Access Compliance Report

Public Rights-of-Way

Intersection ID: 21411	Main Street: MONROE_RD	Cross Street: SARDIS_RD_NORTH	Location: SW
ADA ID: FFBBFE2DFC69	Ramp Type: Para	Initial Pass/Fail: Fail	Overall Compliance: No
		Severity Score: 12.5

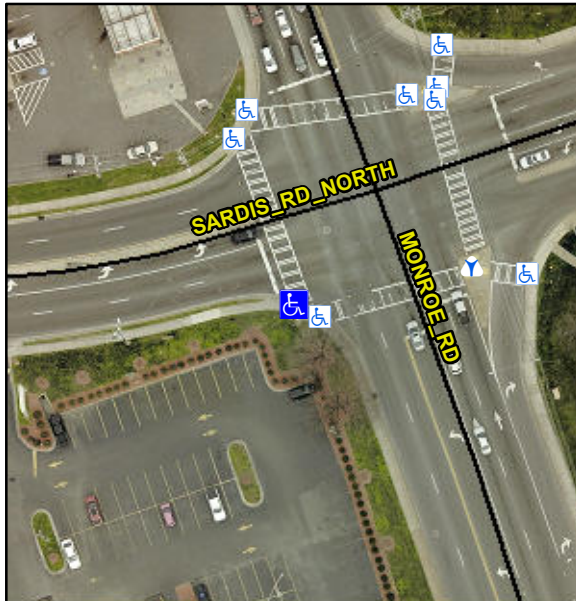
RT RP < 5%

R304.3.2

Compliance	Description	Data	Compliance	Description	Data
N/A	Ramp Length LT (in)	64.0	N/A	Ramp Length RT (in)	65.0
Yes	Ramp Width LT (in)	59.0	Yes	Ramp Width RT (in)	60.0
No	Ramp Slope LT (%)	9.2	Yes	Ramp Slope RT (%)	3.6
Yes	Ramp XSlope LT (%)	1.2	Yes	Ramp XSlope RT (%)	0.2
N/A	Landing Length (in)	N/A	N/A	DWS Provided?	N/A
N/A	Landing Width (in)	N/A	N/A	DWS Contrast?	N/A
N/A	Landing Slope (%)	N/A	N/A	DWS Length (in)	N/A
N/A	Landing X Slope (%)	N/A	N/A	DWS Full Width?	N/A
N/A	Landing Curb? (Y/N)	N/A	N/A	DWS Offset (in)	N/A
N/A	Shared Landing?	N/A			
N/A	Gutter Ponding?	N/A	N/A	Gutter Slope (%)	N/A
N/A	Gutter Lip Ht (in)	N/A	N/A	Gutter X Slope (%)	N/A
N/A	Painted X Walk1?	Yes	N/A	Painted X Walk2?	N/A
	X Walk 1 Direction	To NW		X Walk 2 Direction	N/A
N/A	X Walk 1 Width (in)	111.0	N/A	X Walk 2 Width (in)	N/A
	X Walk 1 Slope (%)	2.6		X Walk 2 Slope (%)	N/A
	X Walk 1 X Slope (%)	1.3		X Walk 2 X Slope (%)	N/A
N/A	Ramp inside XWalk1?	Yes	N/A	Ramp inside XWalk2?	N/A

Remove & Replace Entire Ramp.
